Groundwater Application Review Summary Form

Application # G- 19469

GW Reviewer Travis Brown Date Review Completed: 5/12/2025

PUBLIC INTEREST REVIEW FOR GROUNDWATER APPLICATIONS

Well Location Map

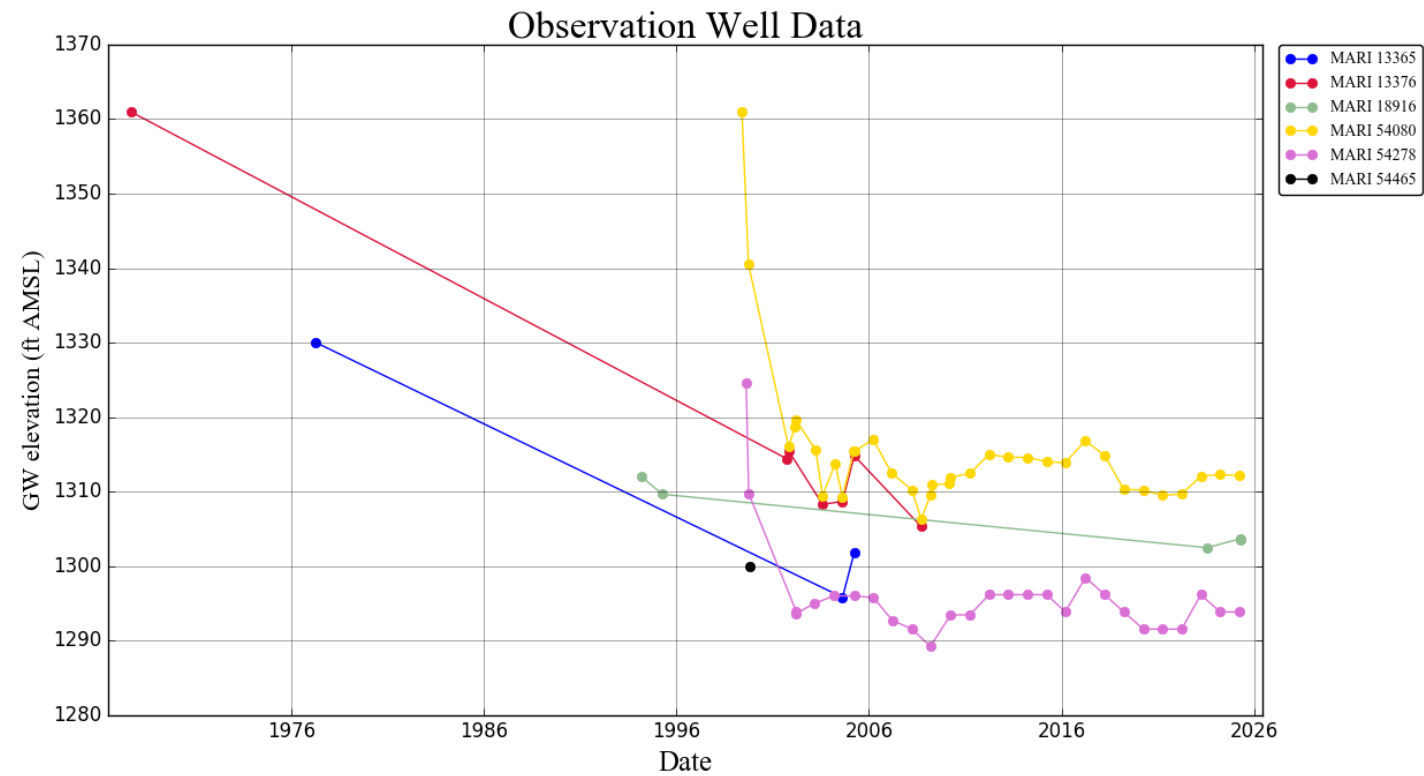
A4. **Comments:** The proposed POA are in Silver Falls State Park, ~9 miles northeast of the City of Stayton.

Cross-Section

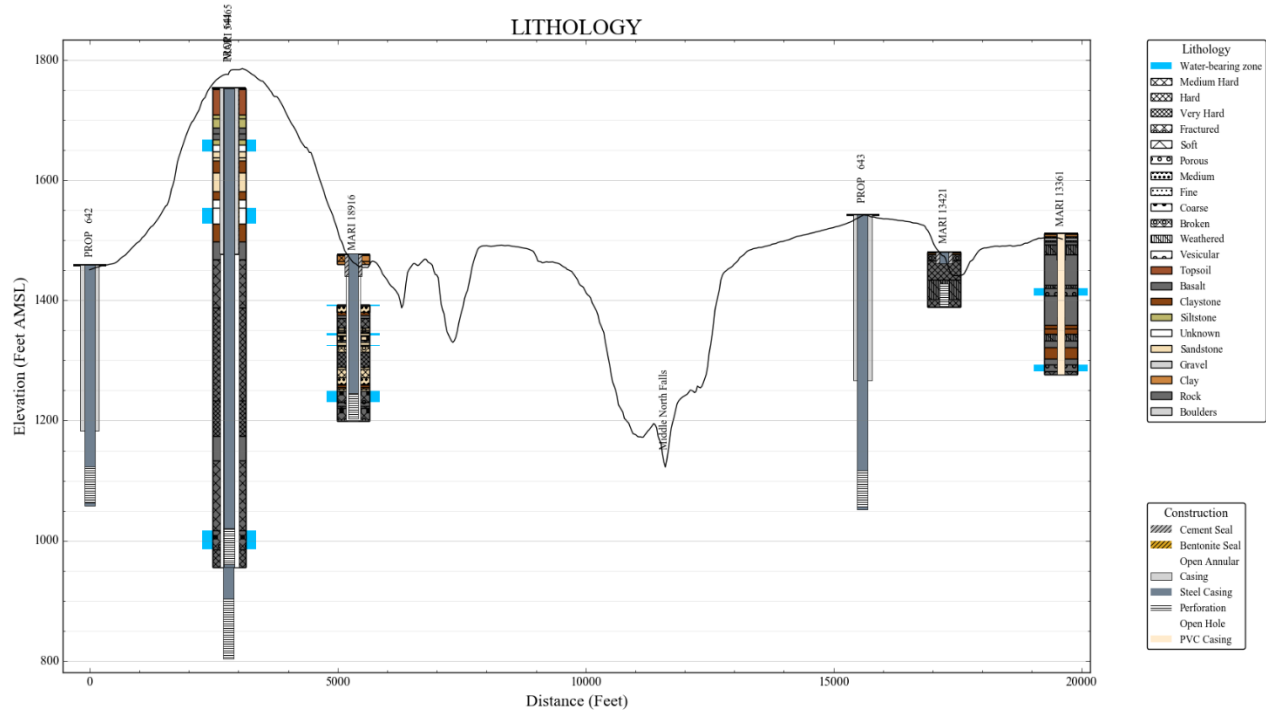
- B3. **Groundwater availability remarks:** The proposed POA wells develop the Columbia River Basalt aquifer system at varying depths. The perforated intervals of the POA wells appear to be exclusively within the Grande Ronde Basalt Formation, although the open annular intervals of POA 1, 2, and 4 extend upward into the Wanapum Basalt Formation. In the subject area, the Grande Ronde Basalt includes at least 5 separate flows from ~10-34 meters (~30-110 ft) thick each. The base of the Grande Ronde Basalt has not been observed in outcrop or well logs in the subject area, so the total thickness of the Formation is unknown (Norman, 1980) (see attached Cross Section).
